State of New Mexico
 Energy, Minerals and Natural Resources

Form C-103
 Revised July 18, 2013

V-F PETROLEUM INC requests to change the SL & BHL for the subject well as follows:

WELL LOCATION AND ACREAGE DEDICATION PLAT

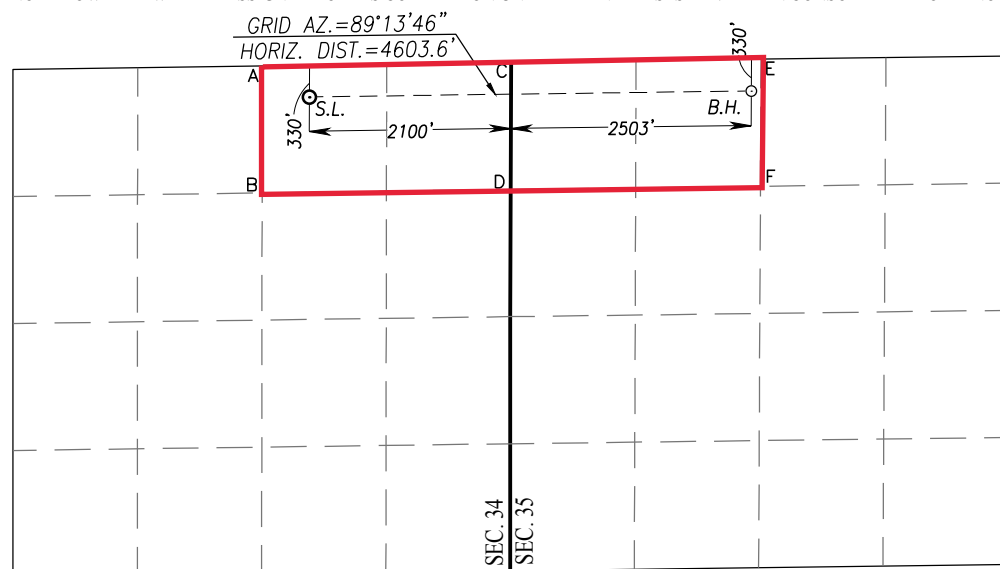
New Requested SL: NWNE, 330 FNL 2100 FEL, Sec. 34 T18S – R28E

New Requested BHL: NENW, 330 FNL 2503 FWL, Sec. 35 T18S – R28E

UL or lot No.	Section	Township	Range	Lot Idn	Feet from the	North/South line	Feet from the	East/West line	County
B	34	18-S	28-E		330	NORTH	2100	EAST	EDDY

UL or lot No.	Section	Township	Range	Lot Idn	Feet from the	North/South line	Feet from the	East/West line	County
C	35	18-S	28-E		330	NORTH	2503	WEST	EDDY

V-F Petroleum, Inc.
 Project: Eddy County, NM
 Site: Sec 34-T18S-R28E
 Well: Burns 34/35 State Com 232H
 Wellbore: Wellbore #1
 Plan: Plan #1 (Burns 34/35 State Com 232H/Wellbore #1)

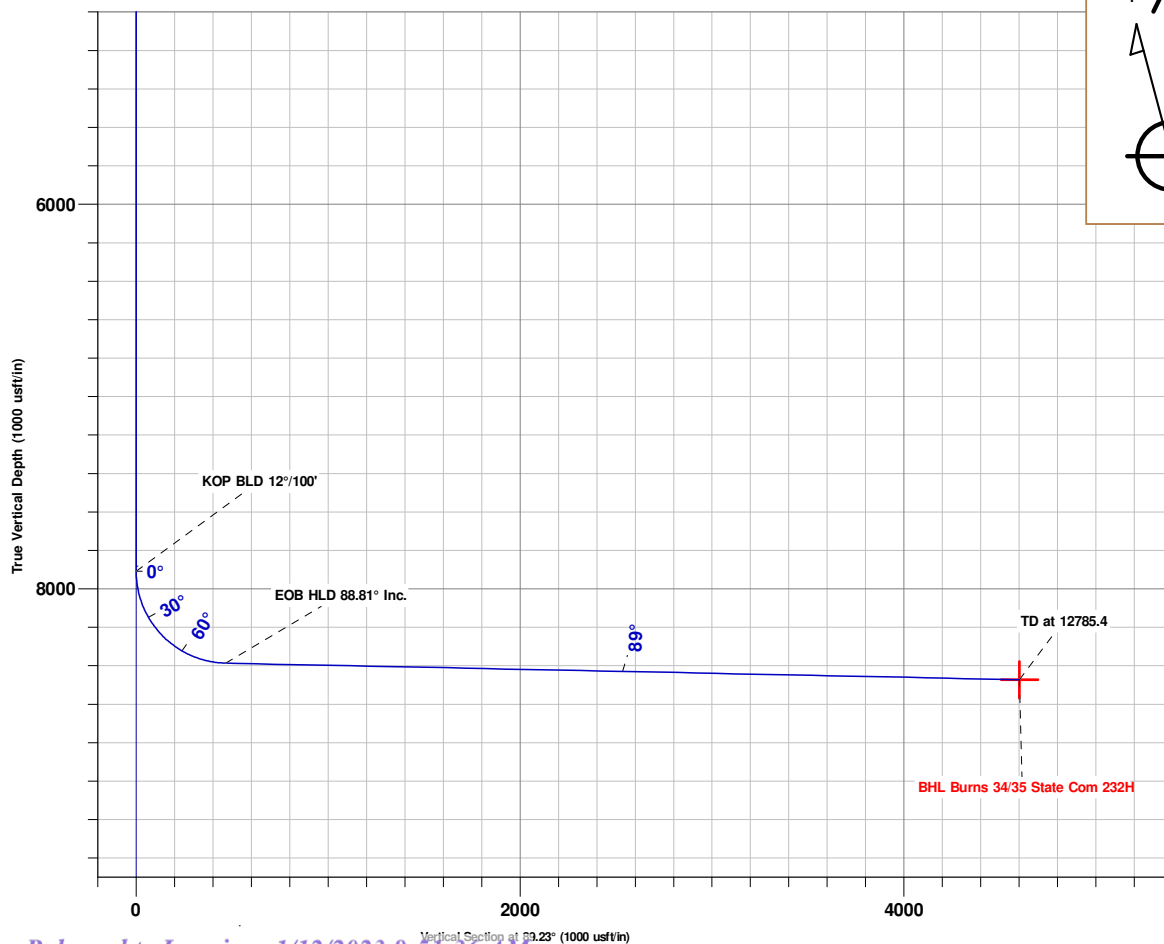
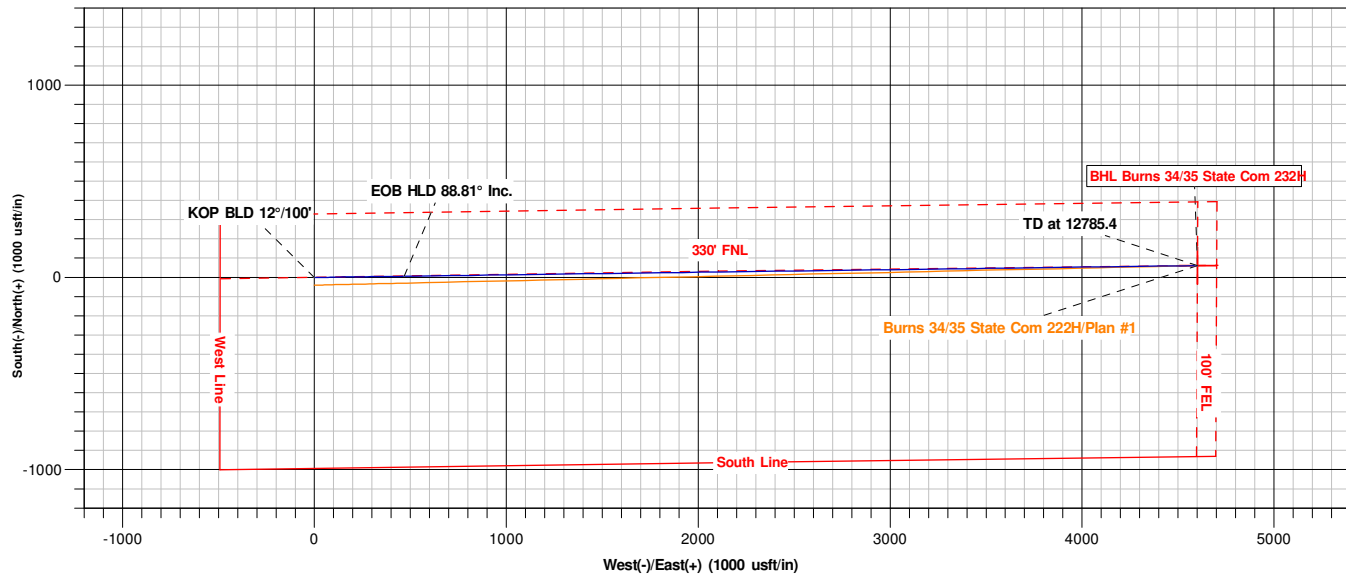
Please see the attached updated documentation.

MD	Inc	Azi	TVD	+N/-S	+E/-W	Dleg	TFace	VSect
0.0	0.00	0.00	0.0	0.0	0.0	0.00	0.00	0.0
7909.6	0.00	0.00	7909.6	0.0	0.0	0.00	0.00	0.0
8649.7	88.81	89.23	8387.0	6.3	467.5	12.00	89.23	467.5
12785.4	88.81	89.23	8473.0	61.9	4602.0	0.00	0.00	4602.4

Name	TVD	+N/-S	+E/-W	Northing	Easting	Latitude	Longitude	Shape
BHL Burns 34/35 State Com 232H	8473.0	61.9	4602.0	622381.40	593936.10	32° 42' 38.987 N	104° 8' 50.517 W	Point
- plan hits target center
